(ONE-STEP FINAL PLAT)

CASE NUMBER: SUB 2002-23 -- WOODBRIDGE SEVENTH ADDITION

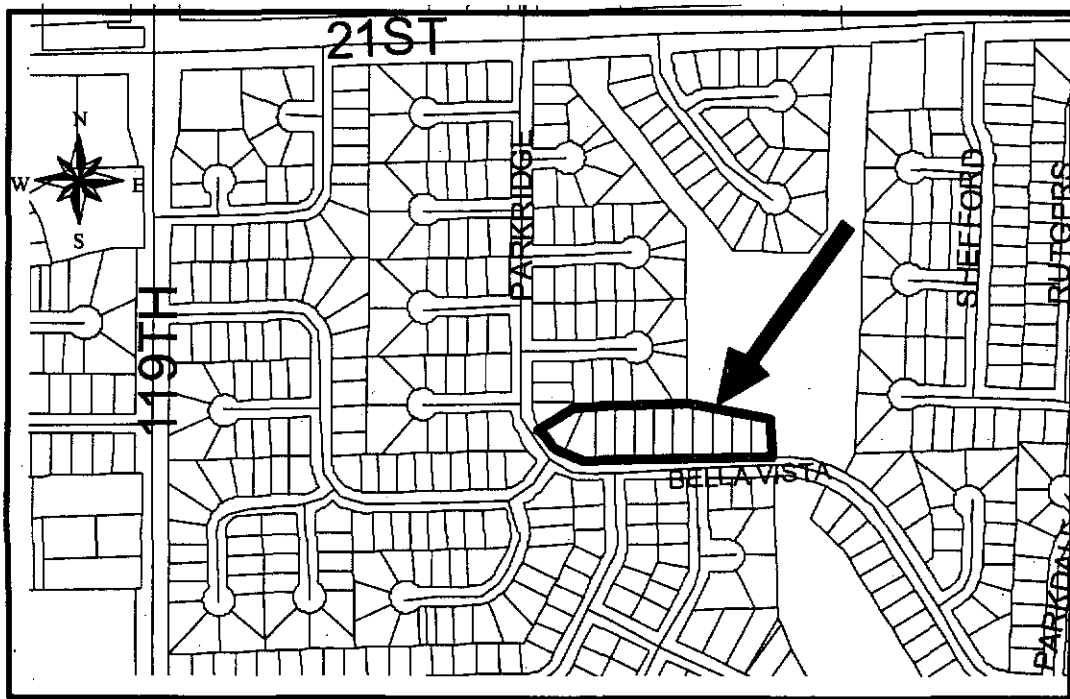
- C. City Engineering needs to comment on the status of the applicant's drainage plan.
- D. The Applicant has platted 20-ft building setbacks which represents an adjustment of the Zoning Code standard of 25 feet for the SF-5, Single-Family District. The Subdivision Regulations permit the setback provisions to be modified by the plat upon the approval of the Planning Commission.

- E. Approval of this plat will require a waiver of the lot depth to width ratio of the Subdivision Regulations for Lots 3-12. The Subdivision Regulations state that the maximum depth of all residential lots shall not exceed 2.5 times the width.

- F. The plat's text shall include language that a drainage plan has been developed for the plat and that all drainage easements, rights-of-way, or reserves shall remain at established grades or as modified with the approval of the applicable City or County Engineer, and unobstructed to allow for the conveyance of stormwater.
